Access Compliance Report

Intersection ID: 27236	Main Street: BALLANTYNE CORPORATE PL	Cross Street: BRIXHAM HILL AV	Location: SW
ADA ID: 39CC7EA96B3F	Ramp Type: Perp	Initial Pass/Fail: Fail	Overall Compliance: No
Severity Score: 25			
Codes/Mitigation Info/Possible Solution		Field Measurements/Component Compliance

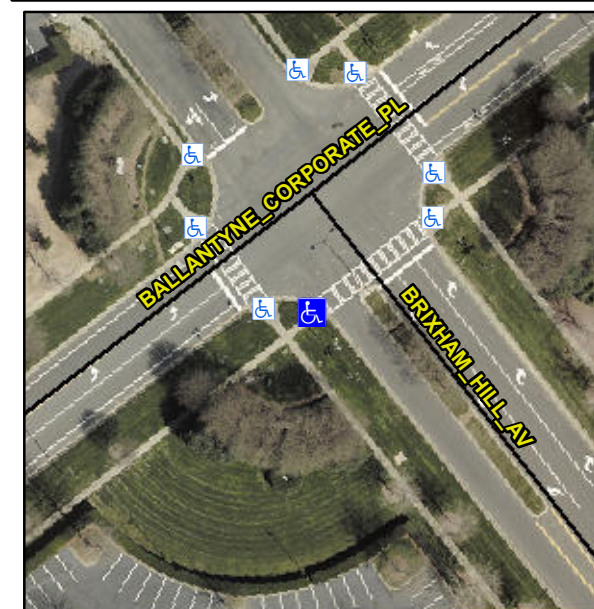
Compliance	Description	Data	Compliance	Description	Data
N/A	Ramp Length (in)	91.0	No	Ramp Slope (%)	13.7
Yes	Ramp Width (in)	48.0	Yes	Ramp XSlope (%)	0.8
N/A	Flare Type LT	N/A	N/A	Flare Type RT	N/A
N/A	Flare Slope LT (%)	N/A	N/A	Flare Slope RT (%)	N/A
N/A	Flare Traversable LT?	N/A	N/A	Flare Traversable RT?	N/A
N/A	Landing Length (in)	N/A	N/A	DWS Provided?	N/A
N/A	Landing Width (in)	N/A	N/A	DWS Contrast?	N/A
N/A	Landing Slope (%)	N/A	N/A	DWS Length (in)	N/A
N/A	Landing X Slope (%)	N/A	N/A	DWS Full Width?	N/A
N/A	Landing Curb? (Y/N)	N/A	N/A	DWS Offset (in)	N/A
N/A	Shared Landing?	N/A			
N/A	Gutter Ponding?	N/A	N/A	Gutter Slope (%)	N/A
N/A	Gutter Lip Ht (in)	N/A	N/A	Gutter X Slope (%)	N/A
N/A	Painted X Walk1?	Yes	N/A	Painted X Walk2?	N/A
	X Walk 1 Direction	To NE		X Walk 2 Direction	N/A
N/A	X Walk 1 Width (in)	111.0	N/A	X Walk 2 Width (in)	N/A
	X Walk 1 Slope (%)	3.0		X Walk 2 Slope (%)	N/A
	X Walk 1 X Slope (%)	1.8		X Walk 2 X Slope (%)	N/A

Remove & Replace Entire Ramp.
